MEMORANDUM

To: Site Plan / Subdivision Committee
From: Lauren A. Wasilauski, Open Space & Stewardship Director
Date: November 16, 2023
Re: PB-07-23 The Malvern School Properties, LP
Preliminary & Final Major Site Plan with Bulk Variances
Block 28010 Lots 57 & 58
982 Georgetown-Franklin Turnpike (Somerset County Route 518)

Figure 1: Screen grab of Montgomery Township GIS webmapper showing critical areas and associated buffer (in red crosshatching and solid pink/red) on subject lots.

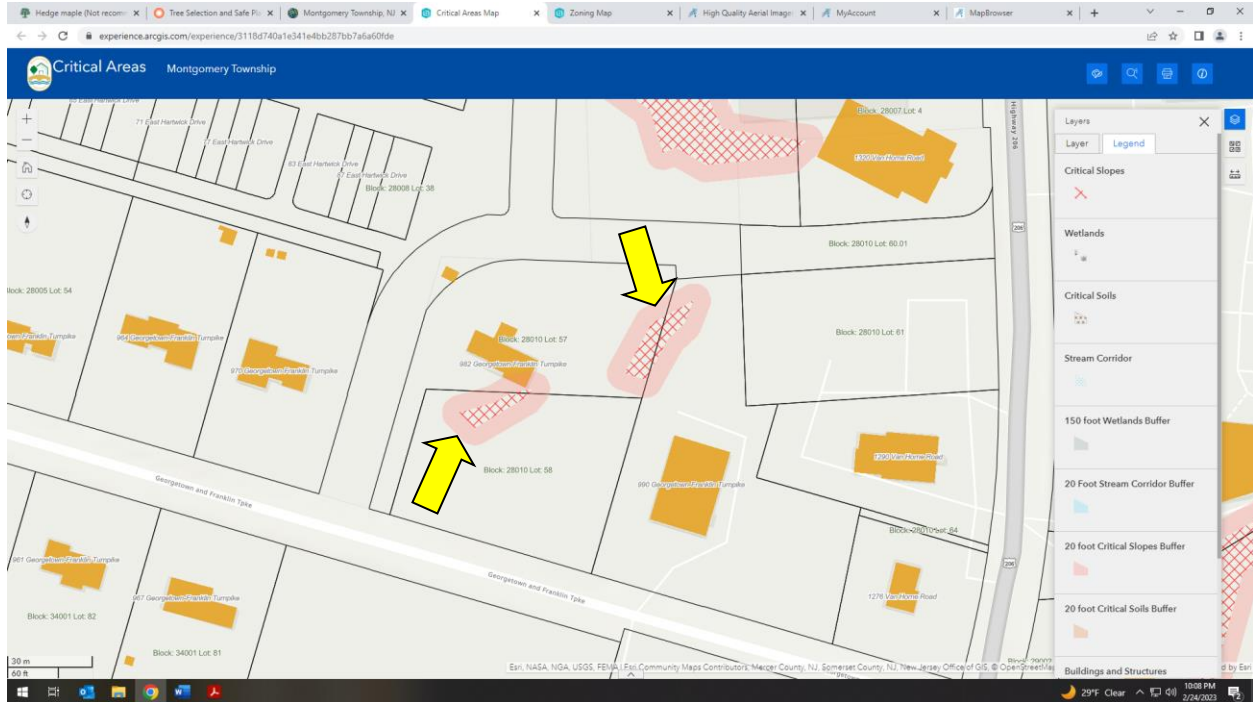
1. There are steep slopes on the property which the EIS report attributes to previous construction activities for the existing single-family dwelling (map on following page). Township Code Section 16-5.6e requires conservation easements or conservation easement deed restrictions on all critical areas. Because these steep slopes are not naturally occurring, this office does not recommend a conservation easement or deed restriction on these areas.
